Access Compliance Report

Public Rights-of-Way

Intersection ID: 12498	Main Street: BELMONT_AV	Cross Street: LOUISE_AV	Location: W
ADA ID: 0B0106E0F7DC	Ramp Type: Perp	Initial Pass/Fail: Fail	Overall Compliance: No
Severity Score: 10			
Codes/Mitigation Info/Possible Solution		Field Measurements/Component Compliance

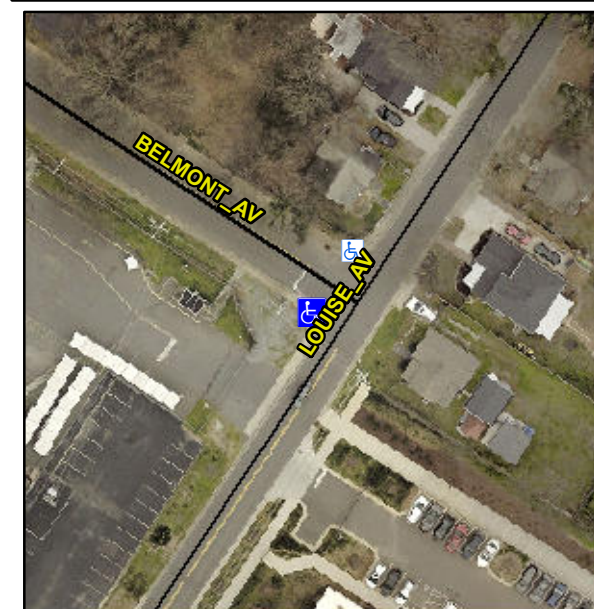
Not Found, R304.5.1, R304.5.3

Compliance	Description	Data	Compliance	Description	Data
N/A	Ramp Length (in)	42.0	Yes	Ramp Slope (%)	7.5
No	Ramp Width (in)	40.0	No	Ramp XSlope (%)	3.0
N/A	Flare Type LT	N/A	N/A	Flare Type RT	N/A
N/A	Flare Slope LT (%)	N/A	N/A	Flare Slope RT (%)	N/A
N/A	Flare Traversable LT?	N/A	N/A	Flare Traversable RT?	N/A
N/A	Landing Length (in)	N/A	N/A	DWS Provided?	N/A
N/A	Landing Width (in)	N/A	N/A	DWS Contrast?	N/A
N/A	Landing Slope (%)	N/A	N/A	DWS Length (in)	N/A
N/A	Landing X Slope (%)	N/A	N/A	DWS Full Width?	N/A
N/A	Landing Curb? (Y/N)	N/A	N/A	DWS Offset (in)	N/A
N/A	Shared Landing?	N/A			
N/A	Gutter Ponding?	N/A	N/A	Gutter Slope (%)	N/A
N/A	Gutter Lip Ht (in)	N/A	N/A	Gutter X Slope (%)	N/A
N/A	Painted X Walk1?	No	N/A	Painted X Walk2?	N/A
	X Walk 1 Direction	To NE		X Walk 2 Direction	N/A
N/A	X Walk 1 Width (in)	N/A	N/A	X Walk 2 Width (in)	N/A
	X Walk 1 Slope (%)	5.5		X Walk 2 Slope (%)	N/A
	X Walk 1 X Slope (%)	1.6		X Walk 2 X Slope (%)	N/A

Remove & Replace Entire Ramp.
